Modification of Development Consent

Application Number:	SSD 7348
Applicant:	Goodman Property Services (Aust) Pty Ltd
Consent Authority:	Minister for Planning and Public Spaces
Site:	Lot 1 DP 663937, Lot 2 DP 1215268, Lot 6 DP 229784, Lot 2 DP 84578, Lot 3 DP 85393 and Lot 11 DP 1178389 2 Aldington Road, Kemp Creek NSW 2178
Development:	A Concept Proposal including: <ul style="list-style-type: none">• concept layout of 22 warehouse buildings inclusive of dock offices and ancillary offices providing 476,000 square metres of gross lettable area, built over five development stages;• concept layout of development lots, internal roads, drainage, landscaping, noise walls, basins and biodiversity offsets; and• development controls A Stage 1 Development including: <ul style="list-style-type: none">• bulk earthworks across all five stages including retaining walls and noise walls;• lead in services including but not limited to drainage, power, sewer, water and telecommunications;• service infrastructure to Precinct 1, including drainage, power, sewer, water and telecommunications;• construction and operation of three warehouse buildings inclusive of dock offices and ancillary offices in Pre

Oakdale West Estate - SSD 7348 MOD 3 Kemps Creek	Estate Masterplan	1:3000 @ A1	OAK MP 02 (F)
			1:8000 @ A3	13 Jan 2020
			Job No 19262

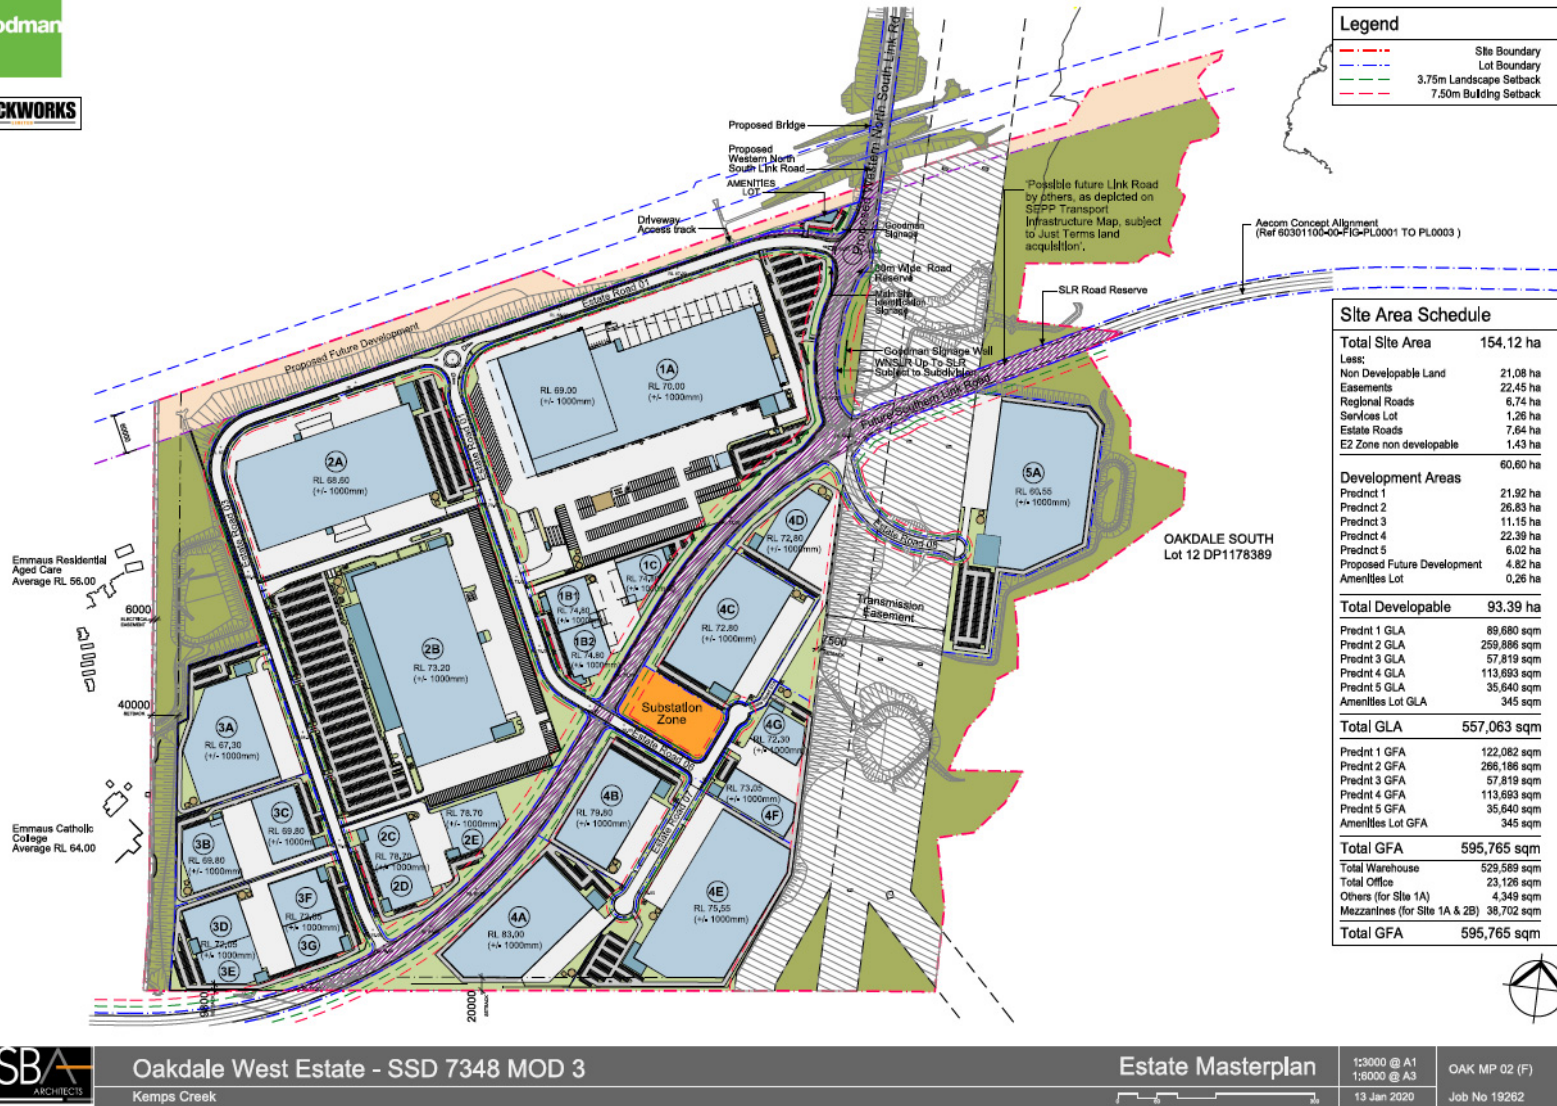
21. Delete Table 6 in Appendix 1 and replace with the following:
The architectural, landscape and civil plans included in the RtS dated 25 March 2020.
22. Replace Figure 1 and Figure 2 in Appendix 1 with new figures as follows:
Figure 1: Concept Proposal Layout (MOD 3)
Figure 2: Staging Plan (MOD 3)
23. Replace Figure 7 in Appendix 5 with a new figure as shown in Appendix 5.

Figure 1: Concept Proposal Layout (MOD 3)

Figure 3: Noise Receivers and Noise Wall Locations

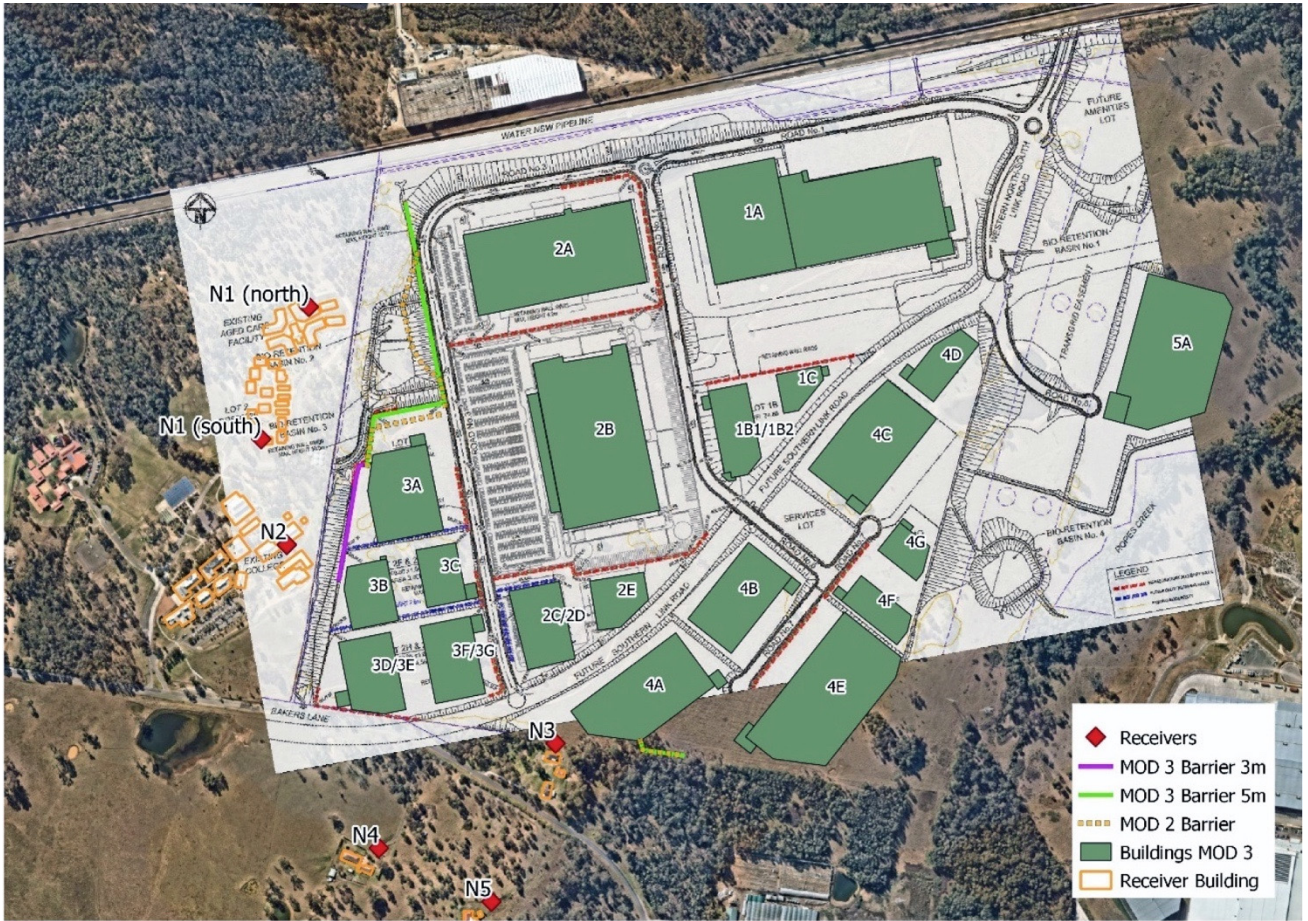
D75(a) The Applicant must install the noise barrier located on the western boundary, as shown on **Figure 7** in **Appendix 5**, to the satisfaction of the Planning Secretary. The noise barrier must be completed no later than 31 October 2020, unless otherwise agreed by the Planning Secretary.
